**RECONSTRUCTION OF ENCINA AVENUE
FROM MIDDLEFIELD ROAD TO END**

**COUNTY PROJECT NO. RW703
PROJECT FILE NO. E5044000**

ADDENDUM NO. 1

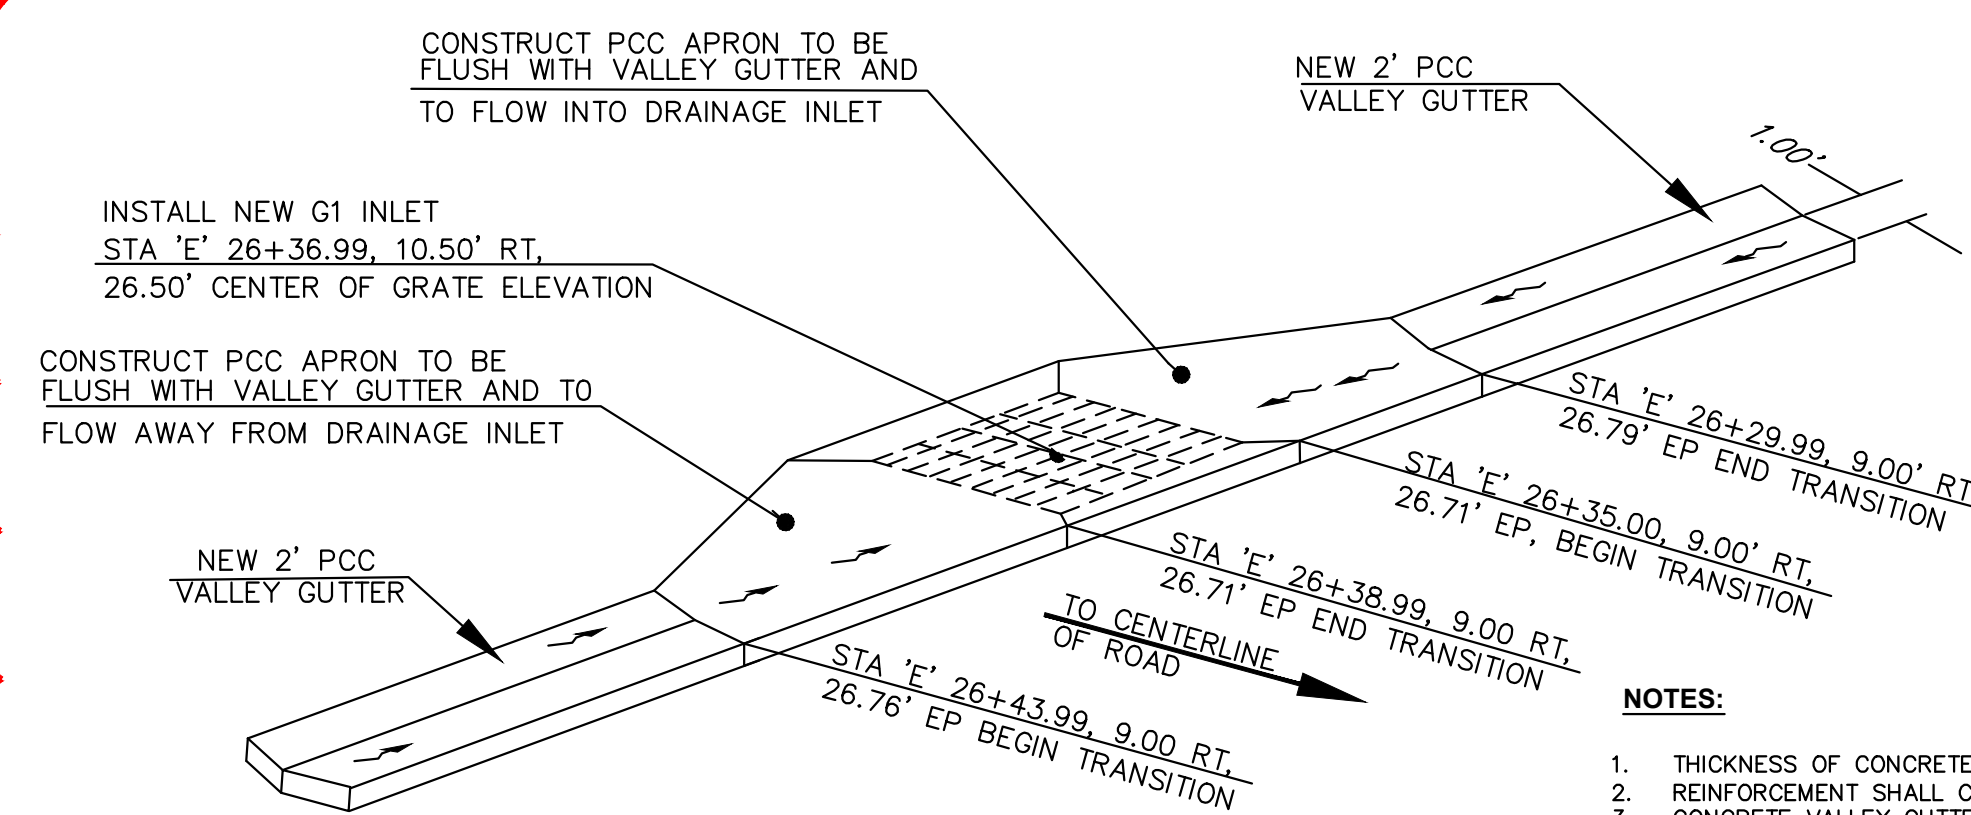
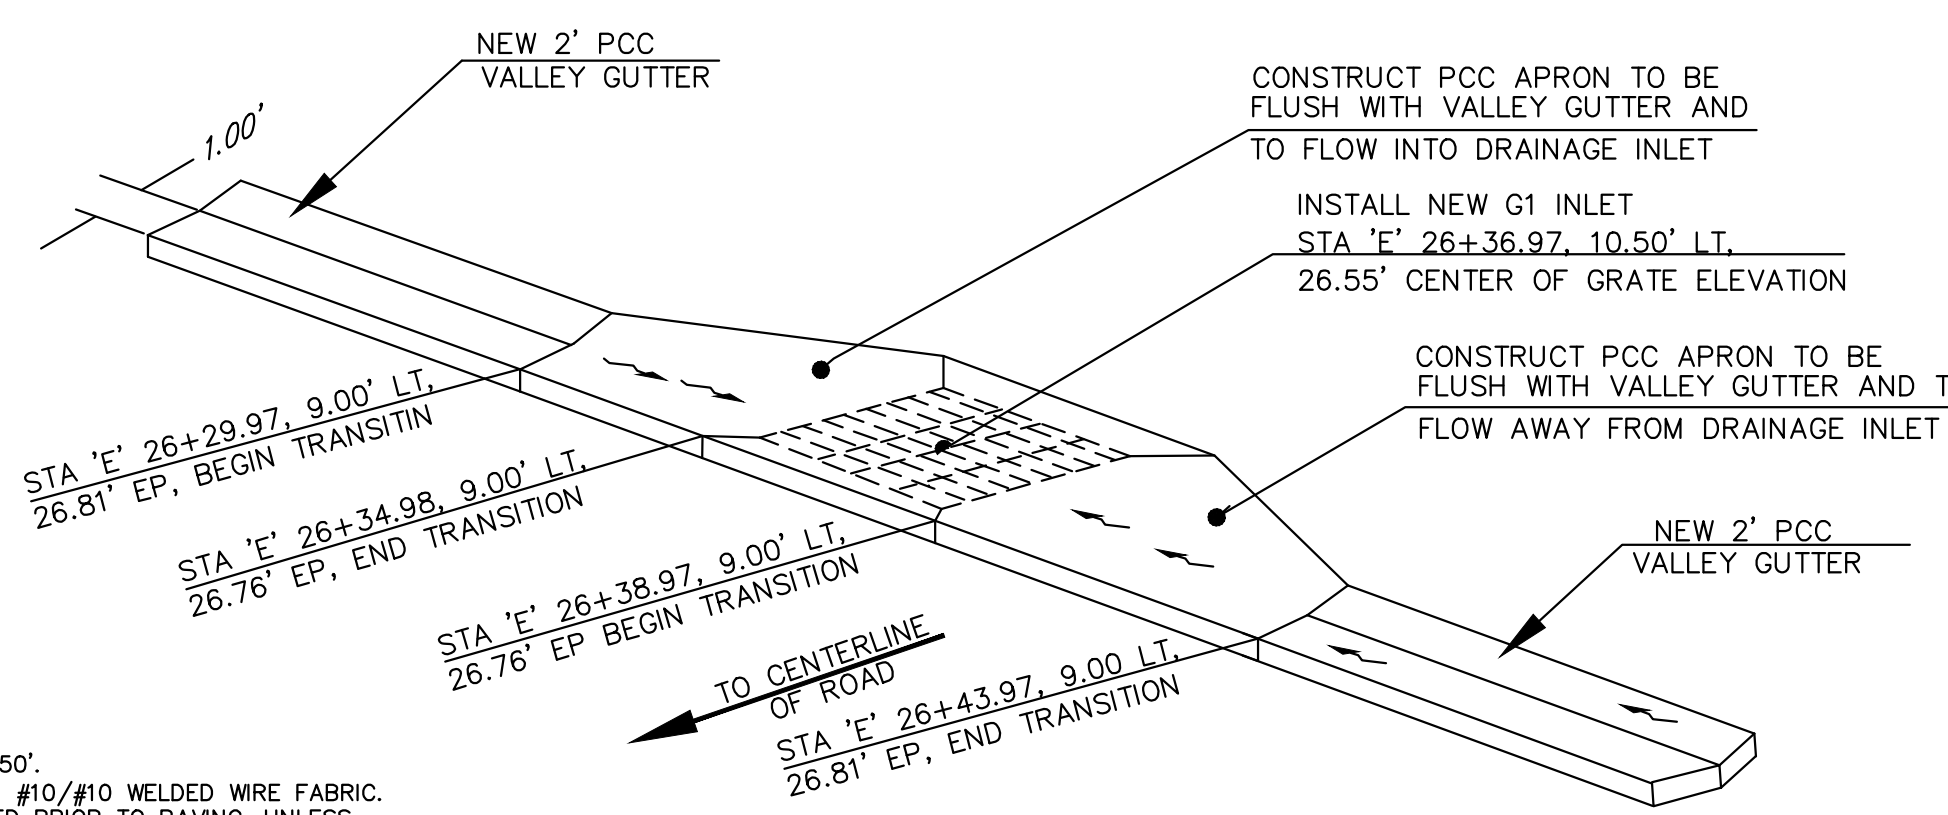
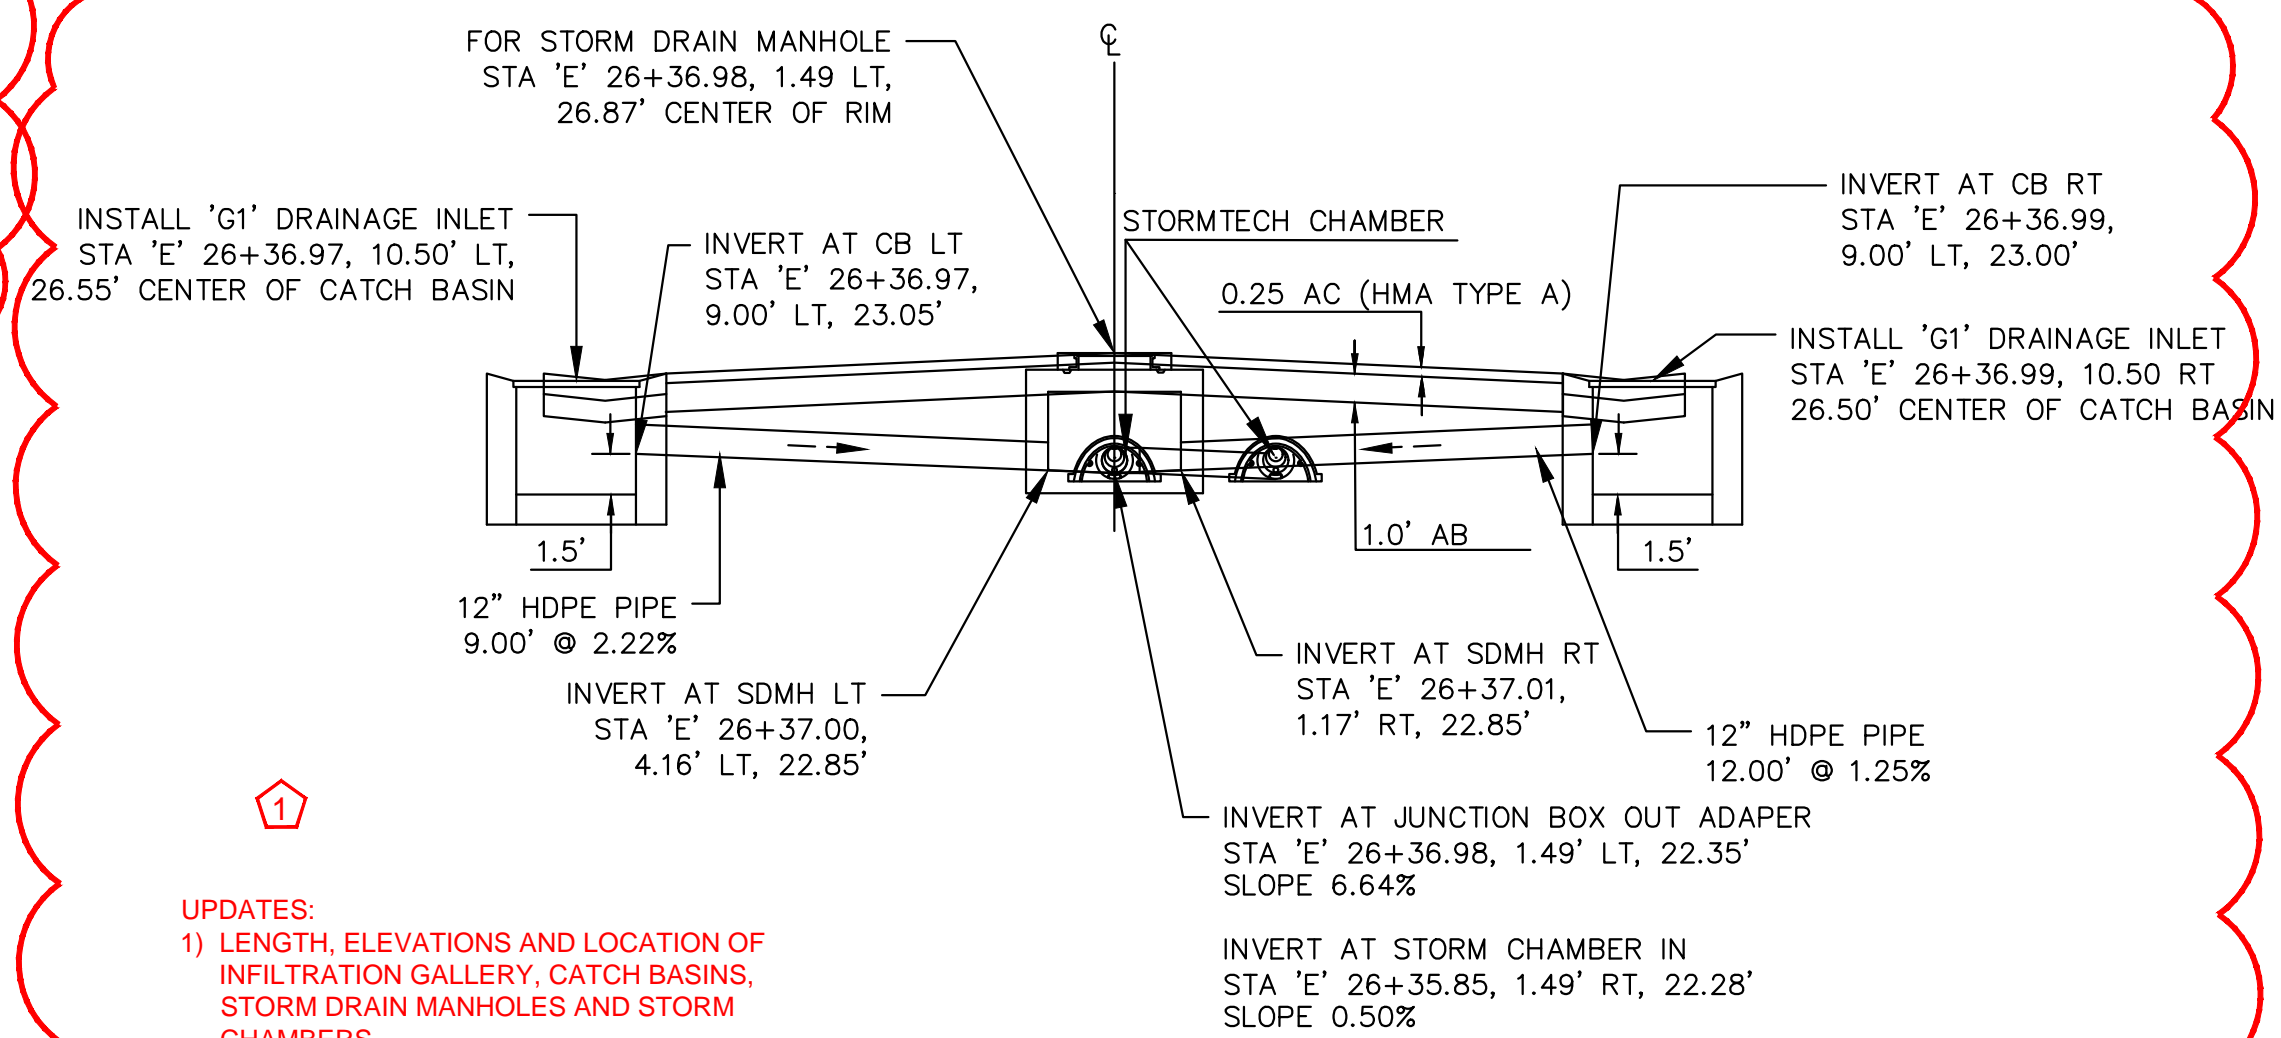
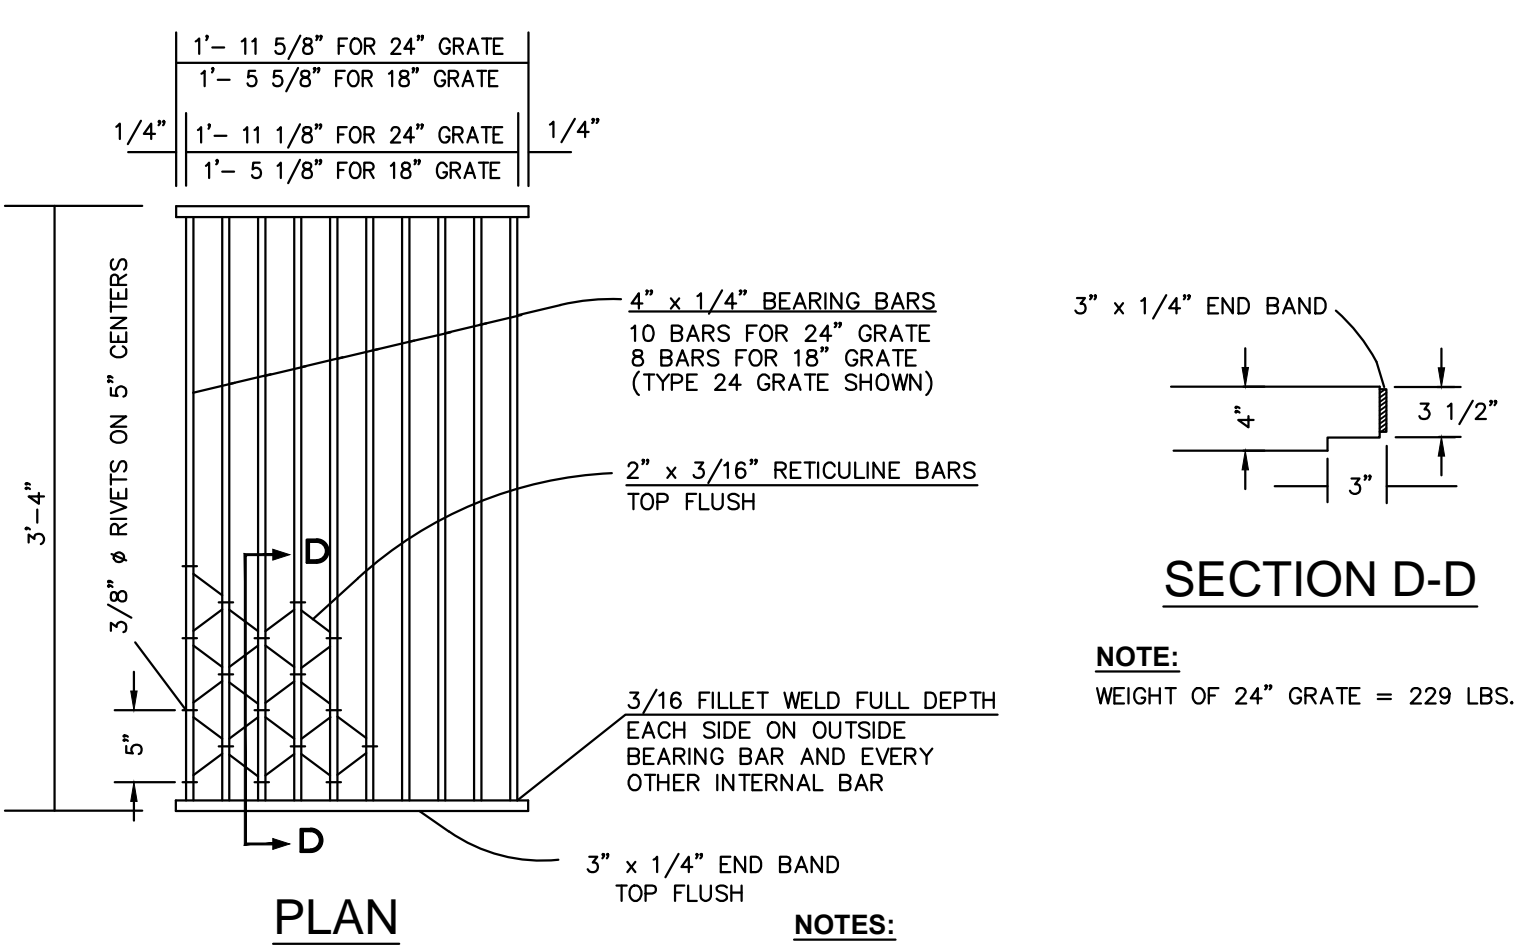
- UPDATES:**
- LENGTH, ELEVATIONS AND LOCATION OF INFILTRATION GALLERY, CATCH BASINS, STORM DRAIN MANHOLES AND STORM CHAMBERS

- UPDATES:**
- LENGTH, ELEVATIONS AND LOCATION OF INFILTRATION GALLERY, CATCH BASINS, STORM DRAIN MANHOLES AND STORM CHAMBERS
